SUBJECT: ISSUANCE OF AMENDMENTS - DIABLO CANYON NUCLEAR POWER PLANT
(DCNPP) UNIT NO. 1 (TAC NO. MA8518) AND UNIT NO. 2 (TAC NO. MA8519)

DIABLO CANYON NUCLEAR POWER PLANT, UNIT NO. 1

DIABLO CANYON NUCLEAR POWER PLANT, UNIT NO. 2

ATTACHMENT TO LICENSE AMENDMENT NO. 142

EXAMPLE 1.2-2

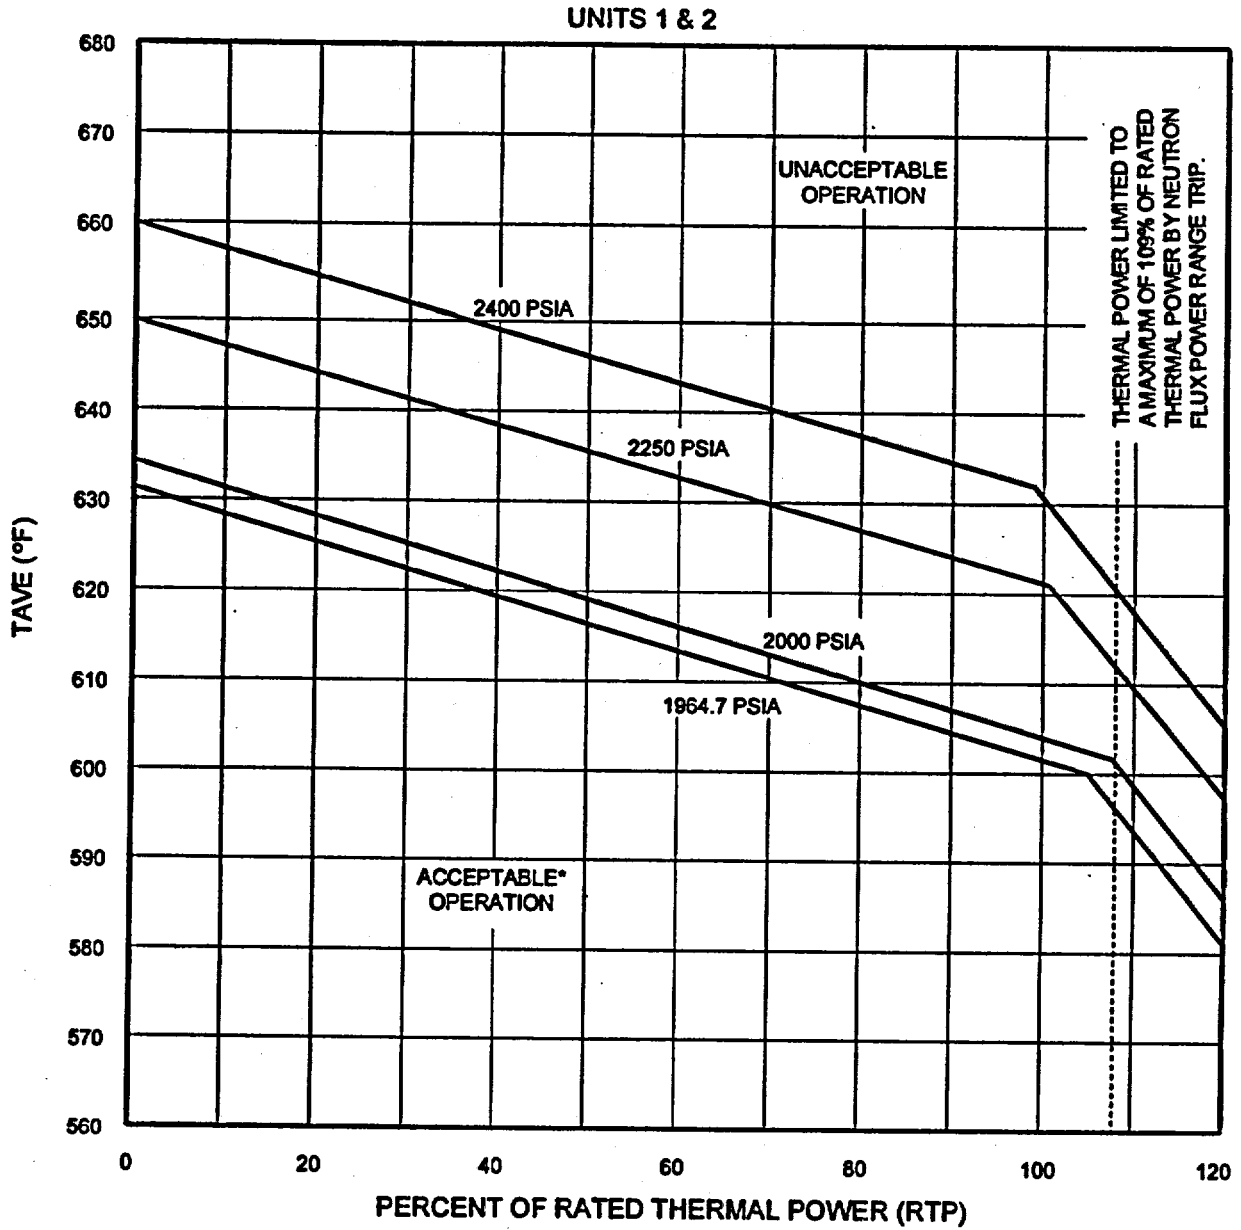
1. ITS 1.2, Example 1.2-2, Required Action A.2 - Correct the misalignment of the logical connectors.
2. ITS 2.1, Figure 2.1.1-1 - Correct spelling error of "NEUTRON" from "NEWTRON" and text misalignment of "TAVE (°F)."

Figure 3.1.3-1 (page 1 of 1)

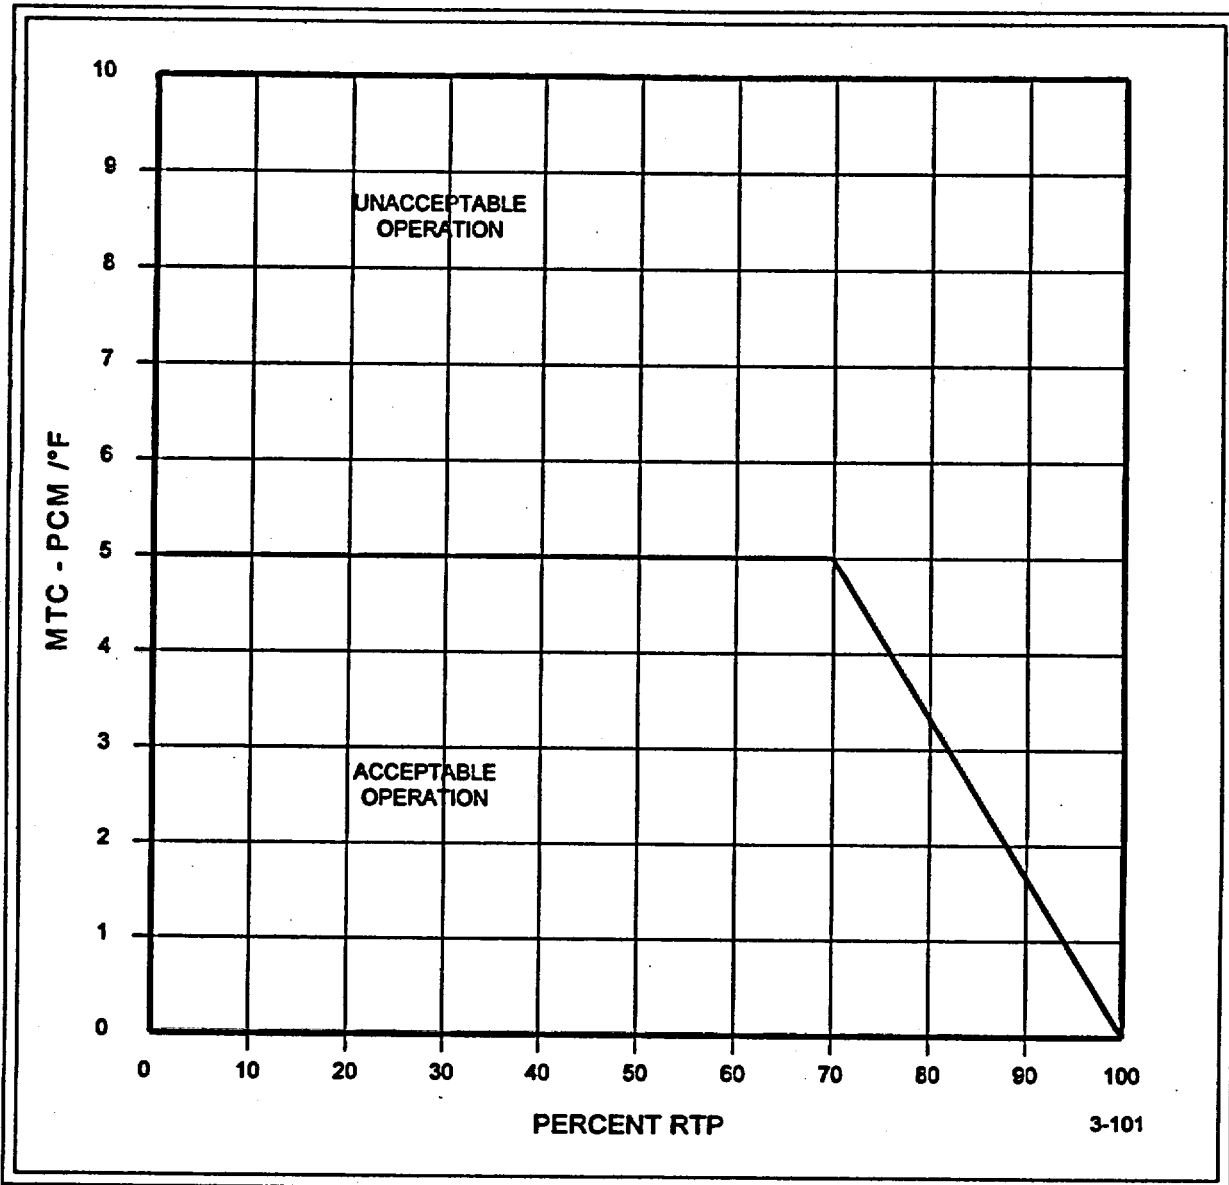
3. ITS 3.1.3, Figure 3.1.3-1 - Revise the legend to state "MTC-PCM°°F" rather than "MTC-PCM."
4. Limiting Condition of Operation (LCO) 3.2.2, Required Action A 1.2.2. - Correct completion time misalignment.
